**Exception Request No.: 9 (Rev 2)**  
**Town: Plymouth**  
**Highway: US 3 (Tier 2)**  
**Section: WBR3**  
**Station: 2492+70 to 2499+71±**  
**Drawing No.: WBR3 C219 to 220**  
**Survey Report Cross Reference No.: WBR3 C215 to C216**  
**Exception Type: Alignment in Pavement**  
**Splice Enclosure in Pavement**

Summary of NHDOT May 31, 2017 Ruling on Exception Request No. 9 (Rev 1) and Justification for Revised Exception Request

EXCEPTION 9 - ALIGNMENT IN PAVEMENT AND SPACE ENCLOSURE IN PAVEMENT; NPT WBR3-UNDERGROUND ALIGNMENT WBR3 SECTION-STA. 2492+70 TO STA. 2499+71  
SCALE: 1"=30'

TRANSMISSION LINE:  
**WBR3**  
EXHIBIT A.1

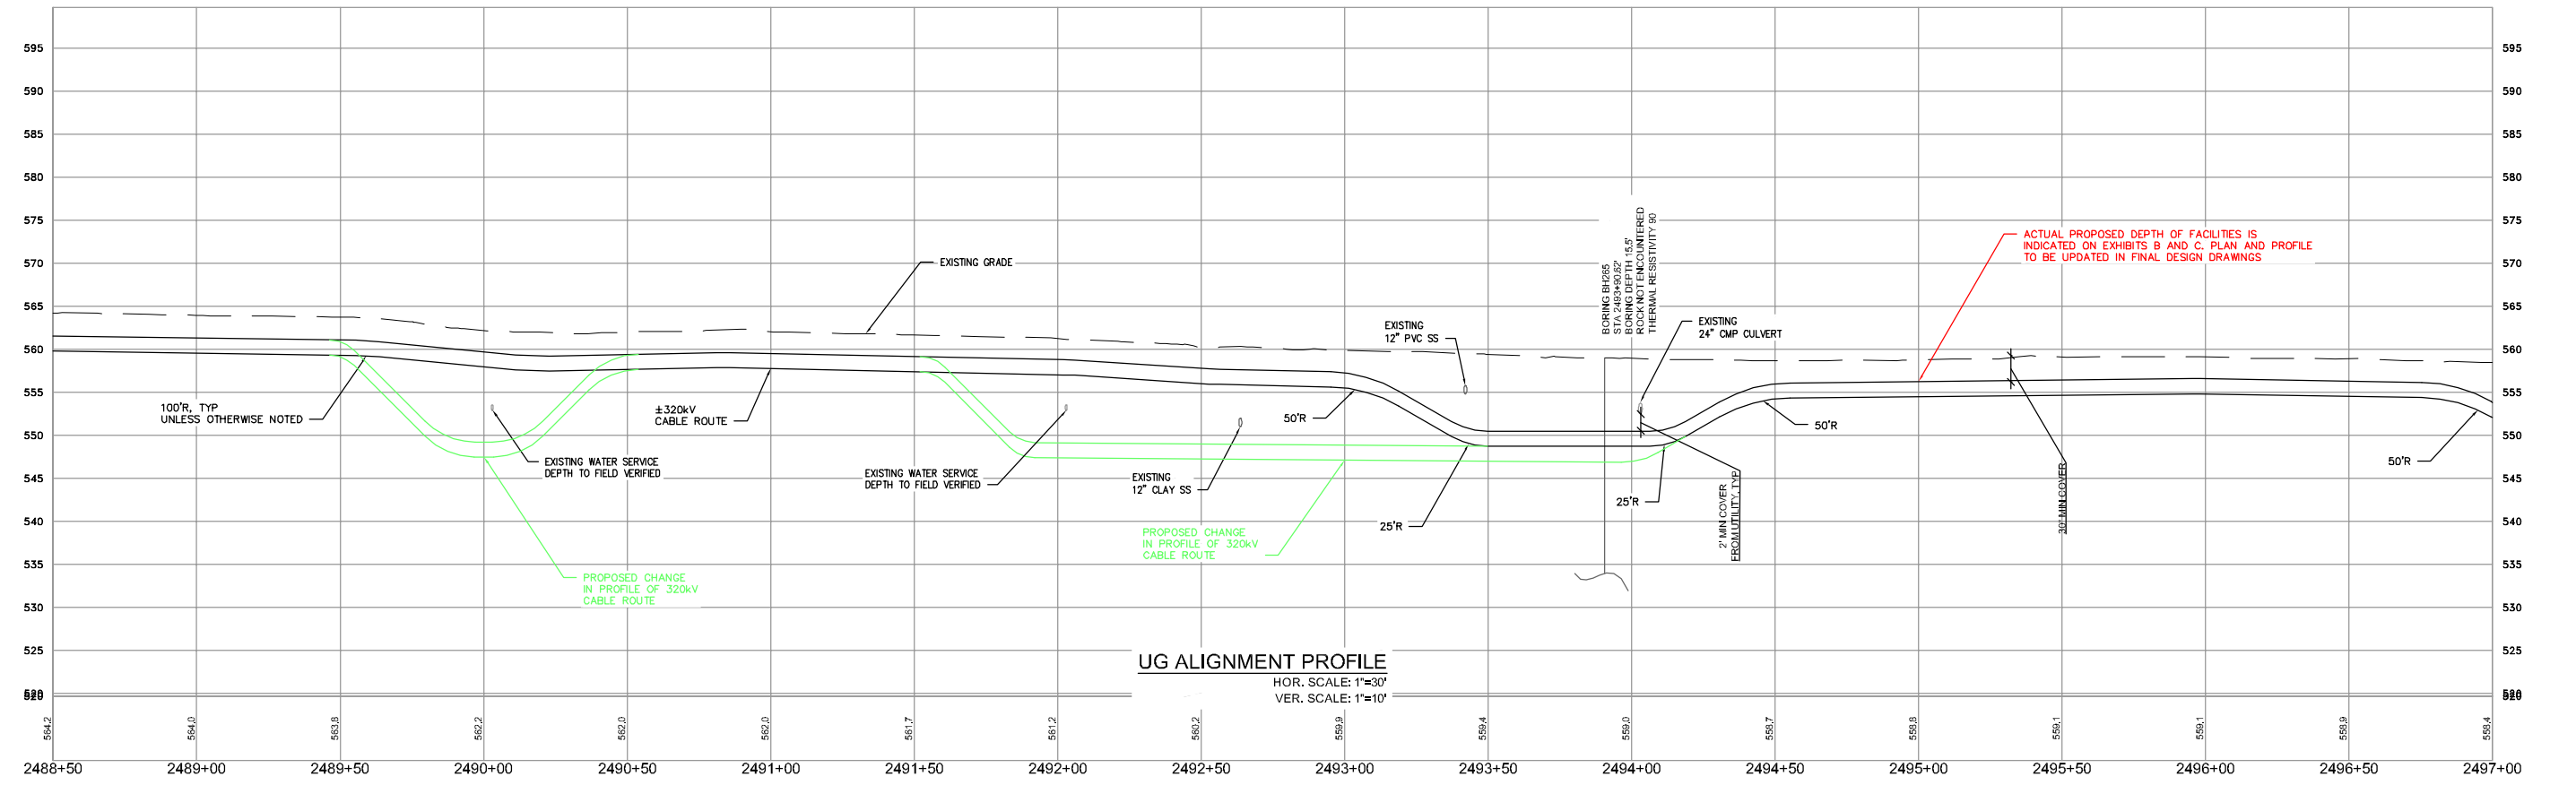
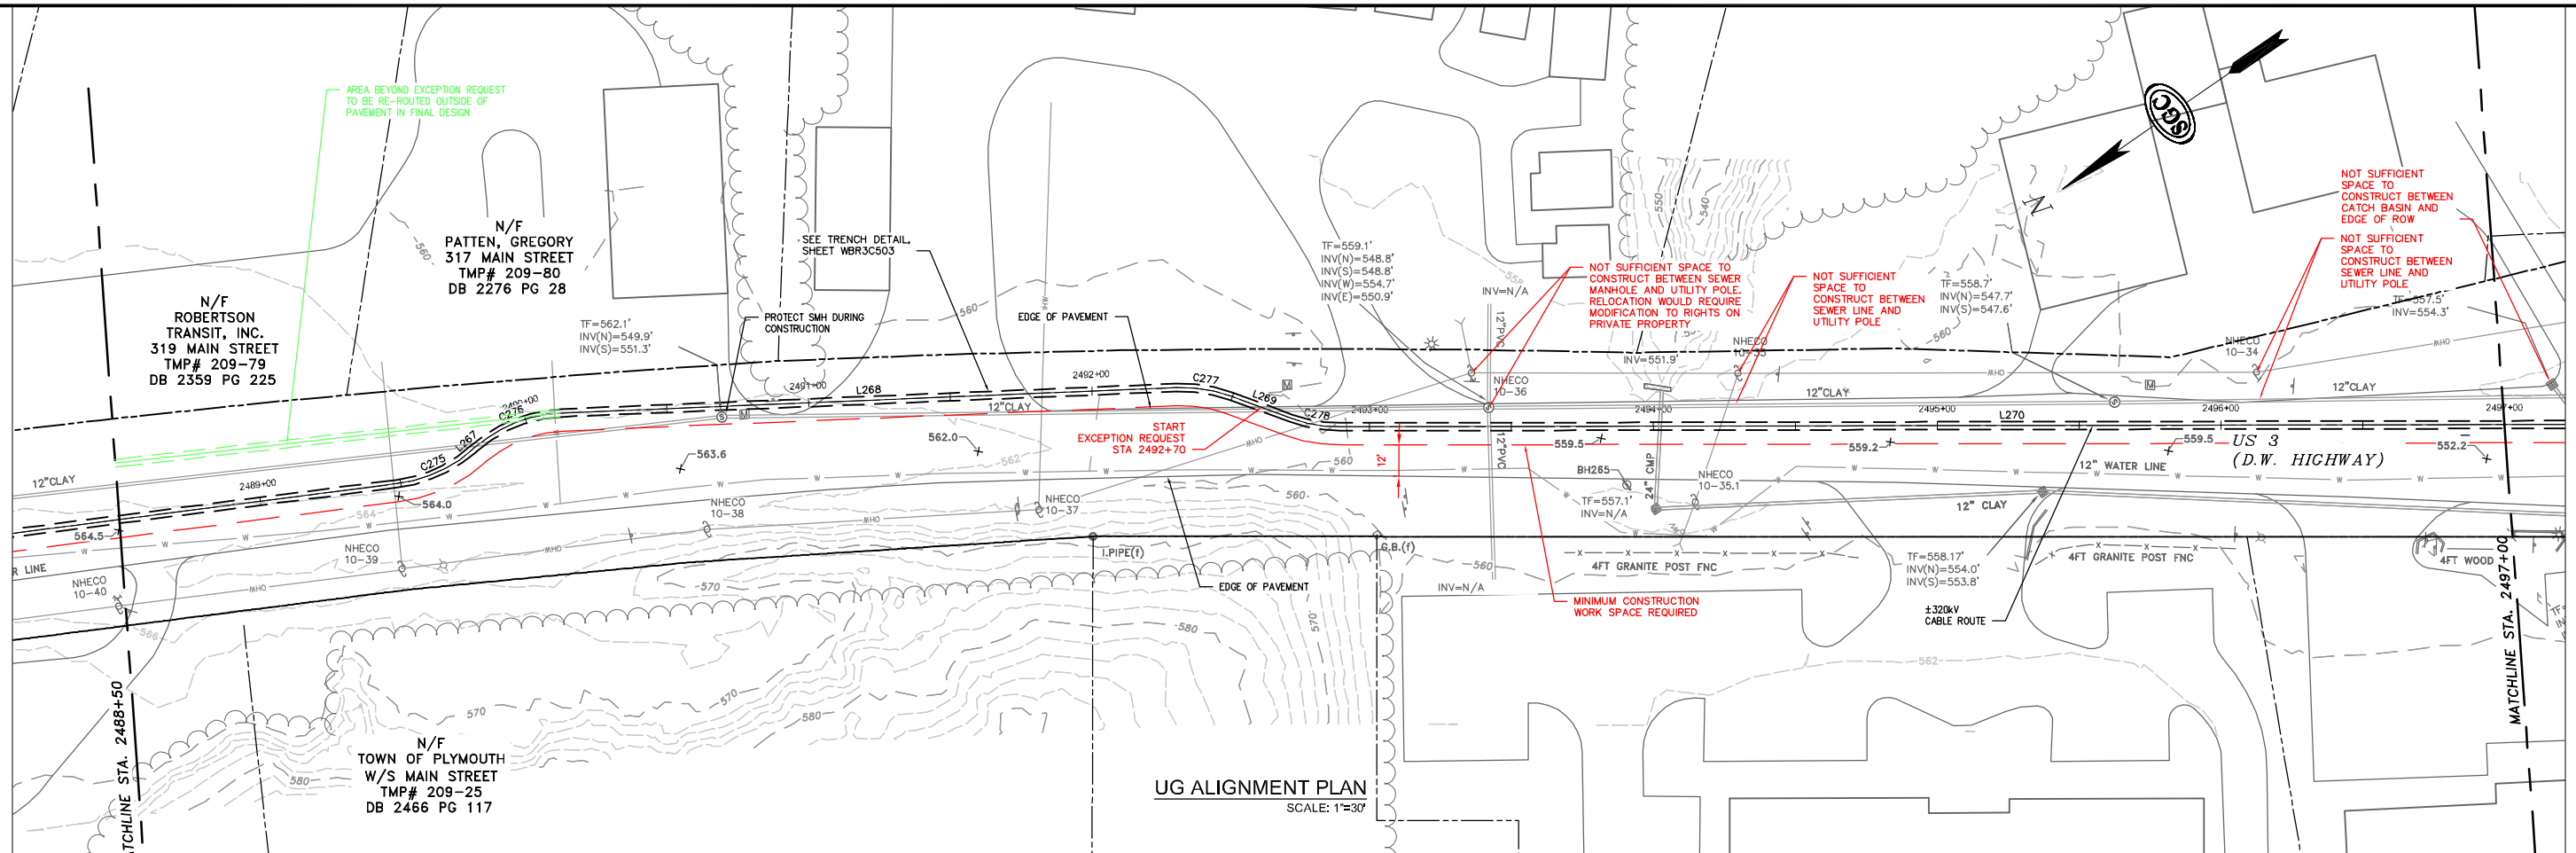
In its May 31, 2017 ruling on Exception Request No. 9 (Rev 1), NHDOT denied the request with instructions that NPT resubmit the request to address the following concerns:

1. Existing NHDOT Right-of-Way (ROW) is not correctly shown between stations 2497+00 and 2505+50. Fence line shown on the easterly side of the ROW between stations 2499+00 and 2503+00 is a ROW fence.
2. It appears that there is sufficient space to move the facility and splice enclosure easterly out of the pavement between stations 2497+00 and 2505+50.

NPT has corrected the ROW boundary shown on the attached drawings consistent with the NHDOT's May 31<sup>st</sup> ruling, and has evaluated whether, in light of this correction, it can move its facilities out of the pavement at this location. Despite this wider ROW, NPT has determined that it cannot move its facilities out of the pavement because NPT must plan to install any facilities and conduct any work within 20 feet of the edge of pavement, consistent with the study area for the draft Environmental Impact Statement prepared by the U.S. Department of Energy (DOE) for purposes of reviewing NPT's application to DOE for a Presidential Permit and NPT's request for a special use authorization from the United States Forest Service.

NPT is therefore renewing its original request for an exception from the UAM guidelines for the location of the cable trench in the pavement on US 3, Daniel Webster Highway from STA 2492+70 to 2499+71± of the NPT WBR3 underground alignment, Sheets C219-C220, and the splice enclosure at STA 2499+50. The proposed alignment within the pavement avoids conflicts with existing utilities and drainage systems located on both sides of the road.

After correcting its drawings to reflect the wider ROW identified in the NHDOT's May 31st ruling, NPT evaluated whether it could relocate the alignment and the splice enclosure outside the pavement by making use of the wider ROW, but has determined it could not. As part of NPT's Presidential Permit process and NPT's request for a special use authorization from the United States Forest Service, the federal agencies have prepared a draft Environmental Impact Statement ("draft EIS"), and are on the verge of issuing a final EIS that is necessary to support issuance of all federal permits. The draft EIS analyzed an area of impact within 20 feet from the edge of pavement on each side of the road. This study area limits the design area available to NPT. The federal agencies may only issue authorizations consistent with the analysis conducted in the National Environmental Policy Act (NEPA) process (e.g., the draft and final EIS), and therefore NPT must plan to install any facilities and conduct any work within this study area.
